Woodstock Conservation Commission Development Review Committee Date: June 15, 2020

RE: Woodstock Valley Country Store expansion project

1484 Route 171 at intersection of Barlow Cemetery Road. Map5787 block 43 lot 15

Approximate location of the Woodstock Valley Country Story expansion project

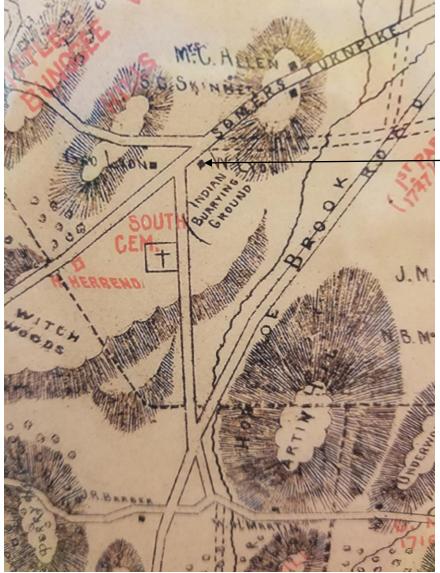
The 1883 map of Woodstock shows a potential archaeological site near this proposed project. While the old map is not suitable for site specific review, and the roadway may have been shifted to its current location, the significance of the site warrants careful review.

Protect the potential archaeological site from disturbance.

- 4. Consult with the state archaeologist regarding the record of the Indian Burial Ground.
- 5. Minimize overnight lighting by use of motion sensor security lighting in every feasible location that lighting is proposed.
